MINUTES
BOARD OF BUILDING STANDARDS/
ARCHITECTURAL BOARD OF REVIEW/SIGN REVIEW
REVIEW MEETING
CITY OF LAKEWOOD
12650 DETROIT AVENUE
AUDITORIUM
MARCH 12, 2026
5:30 P.M.
MEETING RECORDED
<https://www.lakewoodoh.gov/videos-2/>

SUMMARY APPROVED

SOUTH ELEVATION

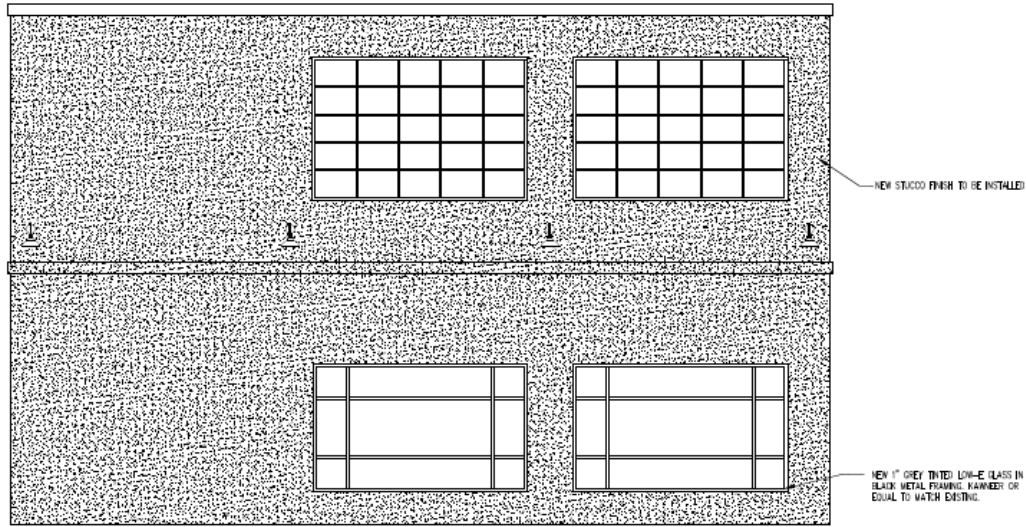
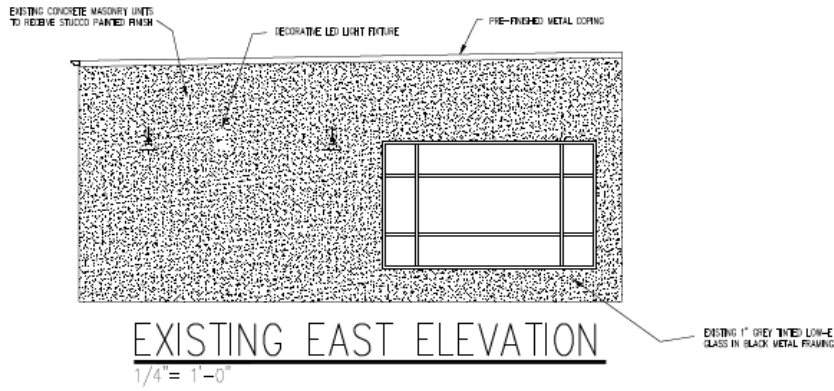
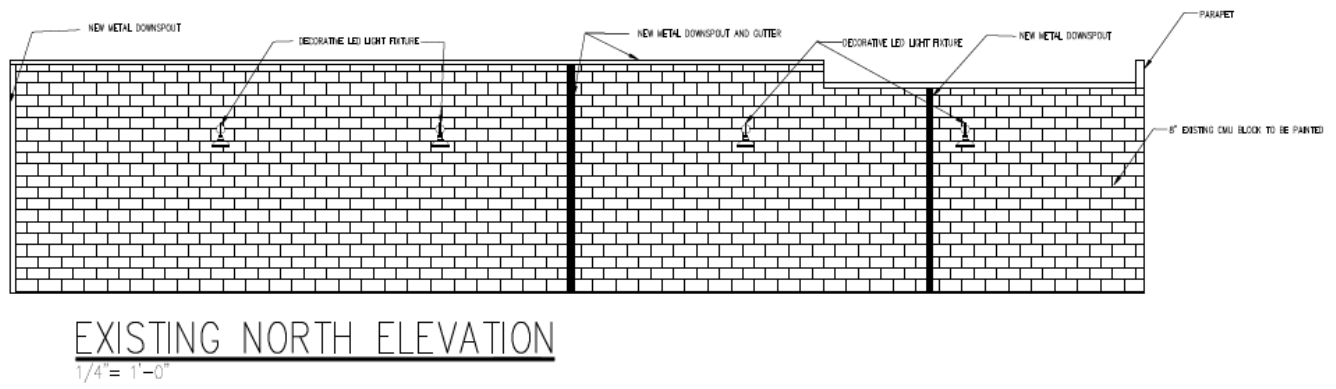
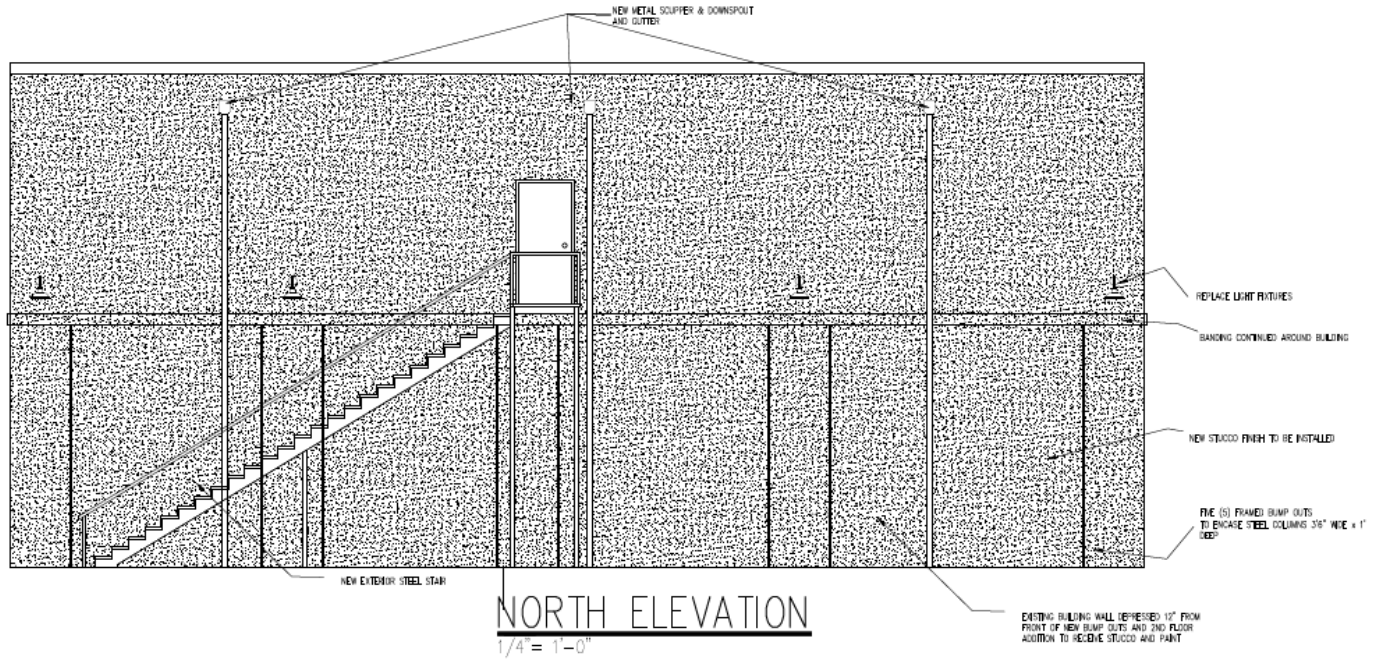
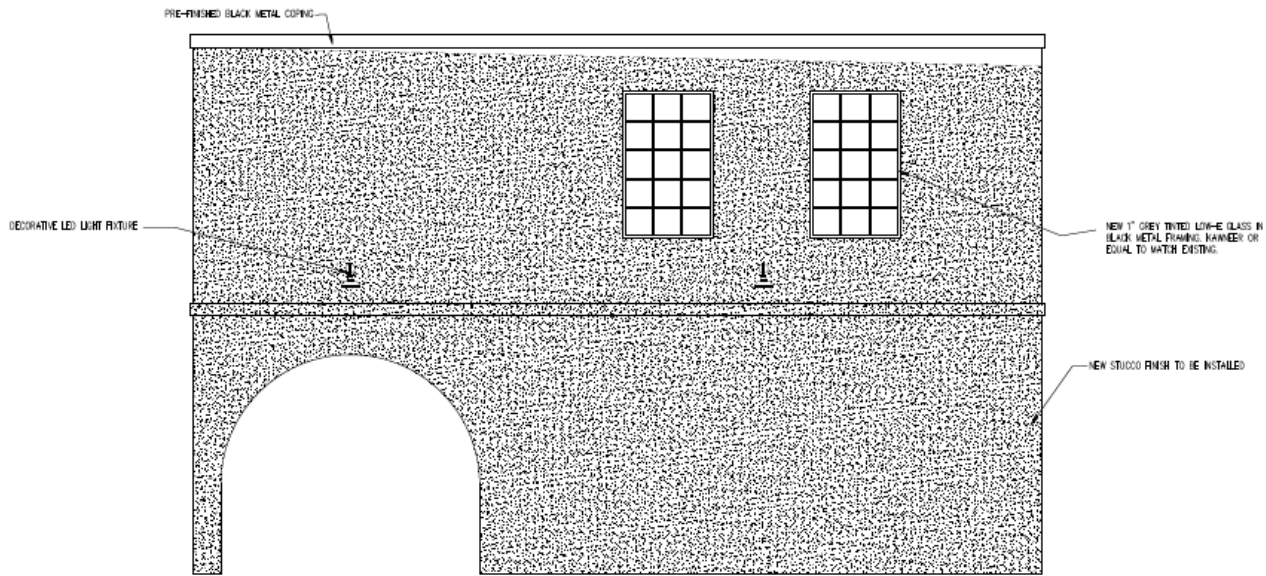
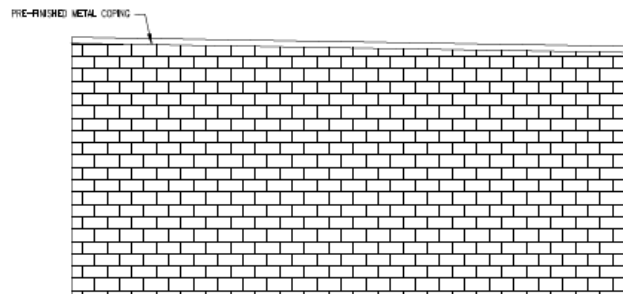
Jake Szaraz, MJM Building Standards, was present to discuss the updated plans. The arches on first floor are now symmetrical. The window elevations on the second floor were changed. He raised

the lights above the banding to make them continuous; the east elevation windows were also changed. Mr. Szaraz provided cut sheets and discussed the landscape changes.

Ms. Plessner questioned the color of the stucco; it will match the original.

Wall Sign – Tabitha in Motion
Tabitha Miner

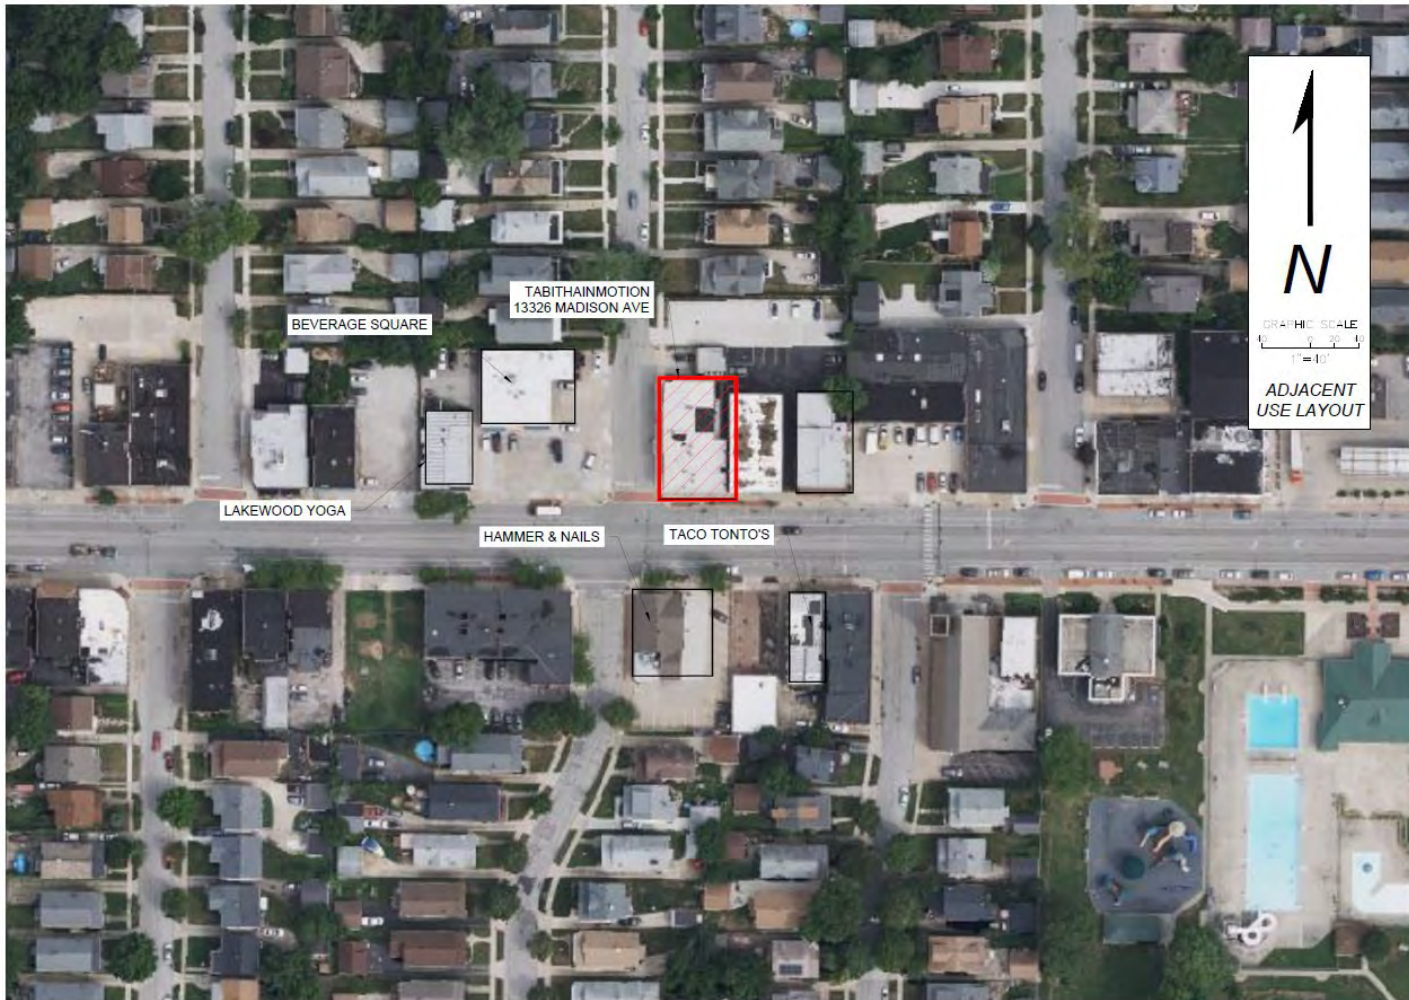
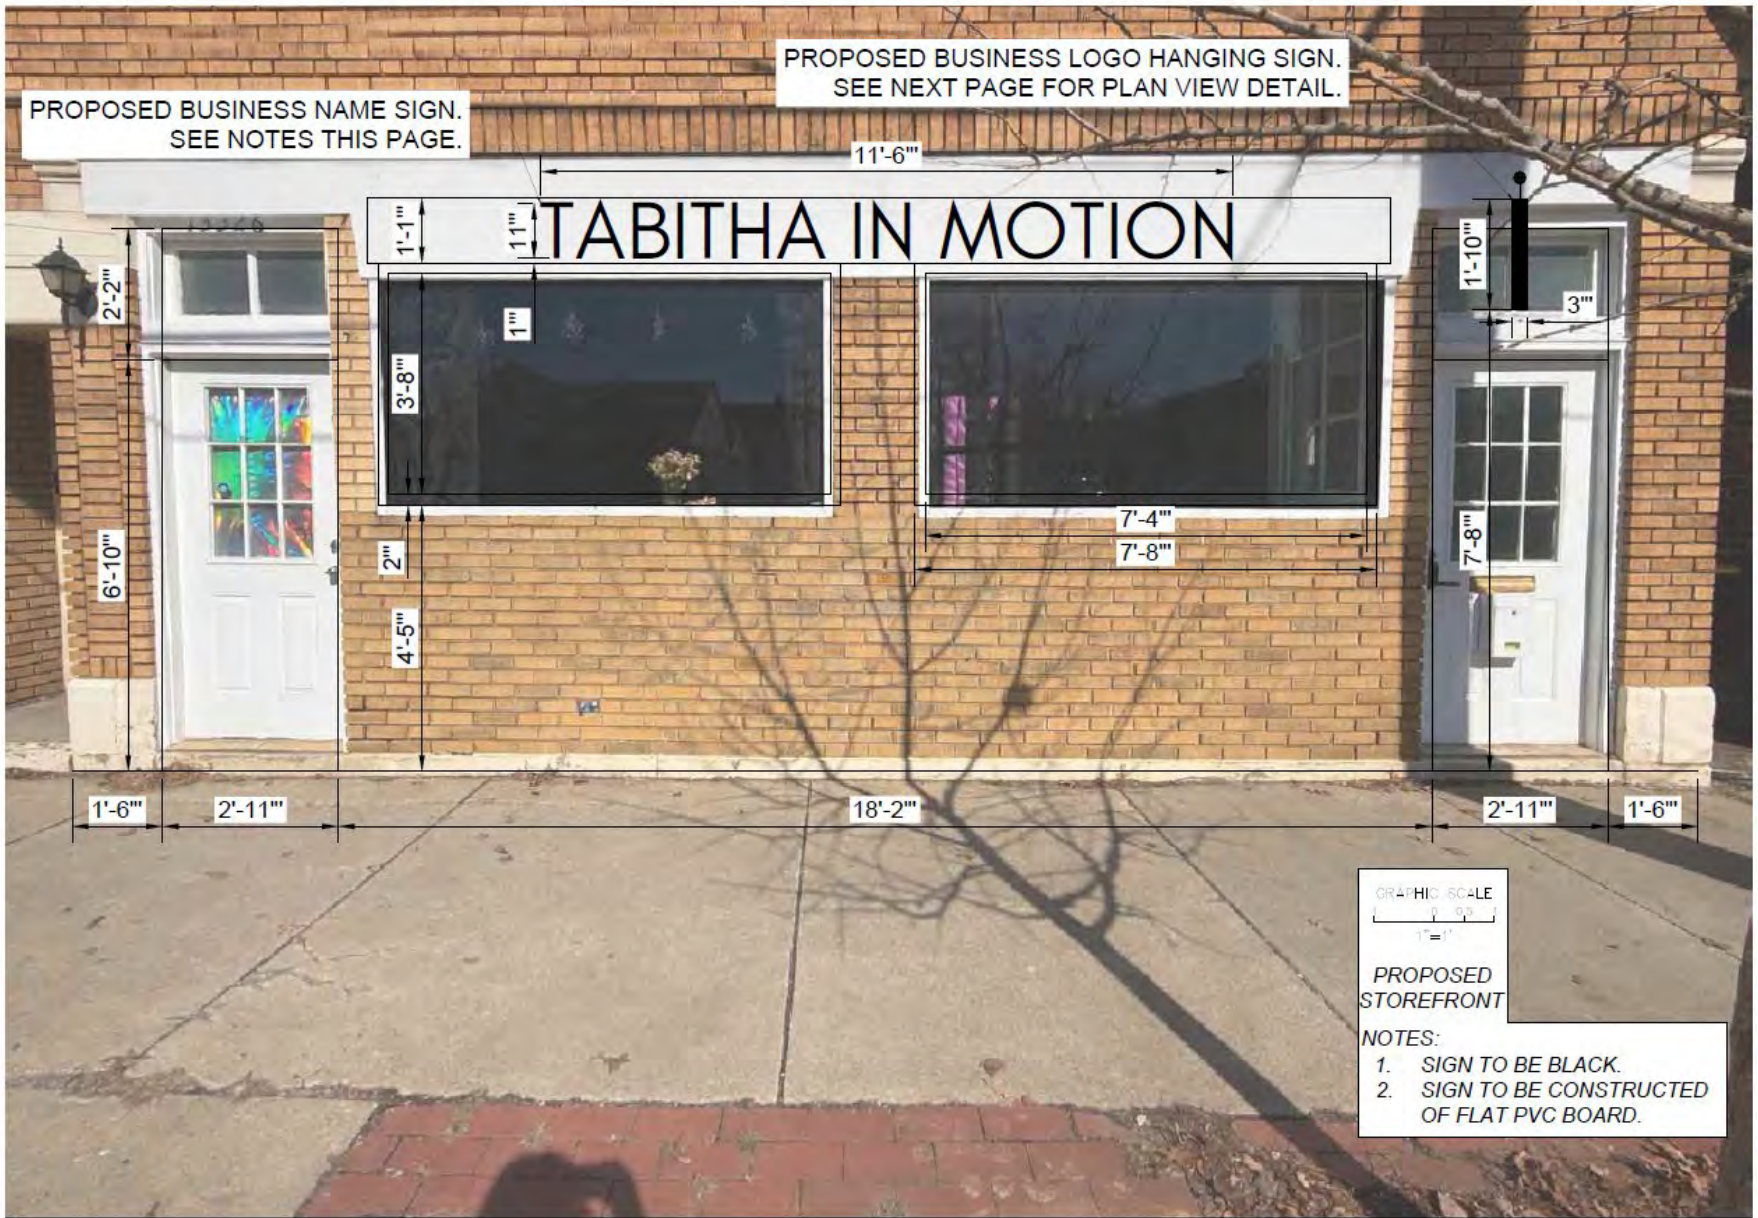
Tabitha Miner, Tabitha In Motion, was present to discuss the plan. Discussion was made on the blade sign and how it be hung and where in front of the transom it will hang. The sign will be hung from gold chain on a gold pole and will have a remote controlled, battery operated light to illuminate the sign and the sign will be hung above the right side door, to help indicate that it is the primary entrance. Discussion was made on the door on the left

side; it is not the primary entry door. The wall sign is fine. Ms. Cramer stated that the signage is well within the requirements.

- Details of the light strip for the blade sign be submitted to Board secretary for administrative approval.
- Additional window signage must get separate approval.

WEST ELEVATION

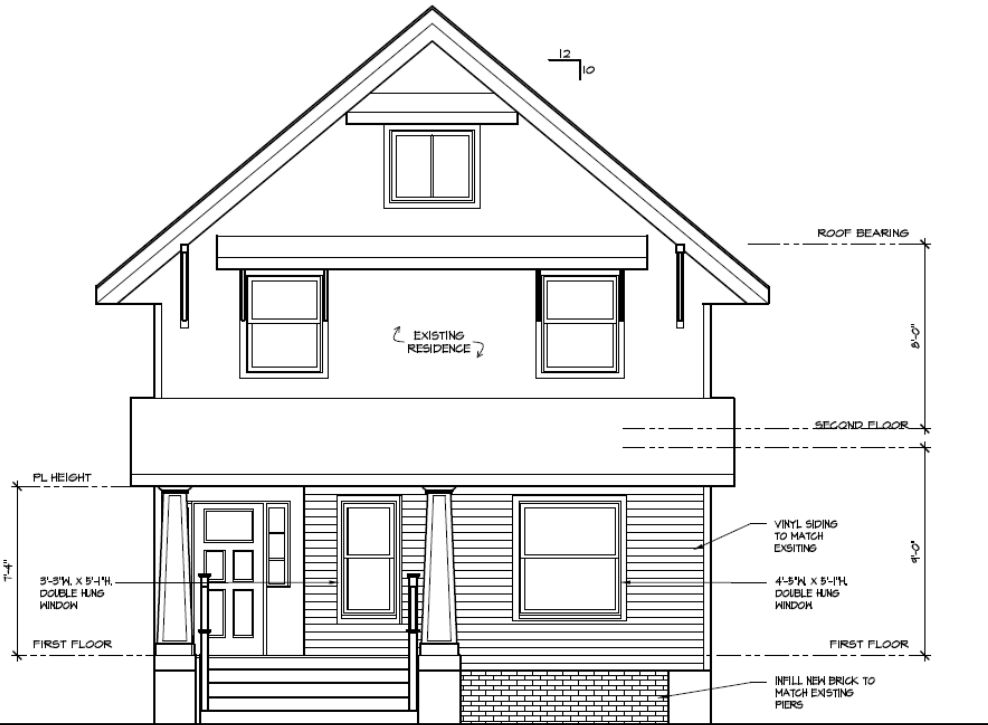
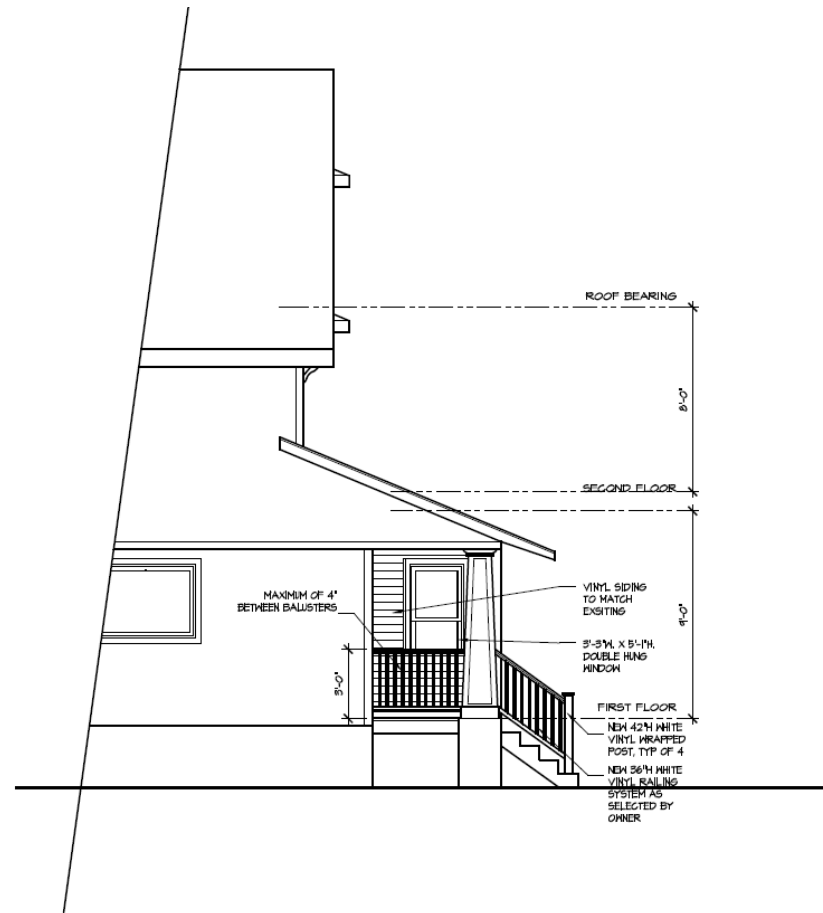
Imad Nader, property owner, was present to discuss the plans. Mr. Nader stated that the foundation on the enclosed porch was changed to rick to match the rest of the home. The column was updated to match the existing column and the column will be built on site. Mr. Nader also discussed the stairs, there will be railing on both sides and the steps will be wide. Trex is the material that will be used for the steps. The wooden shutters will be removed and the front door will remain the same, however, the material around the door will be removed and the side light will remain the same. The Board discussed how the rendering does not match the elevation.

- The rendering not be included in the approval.
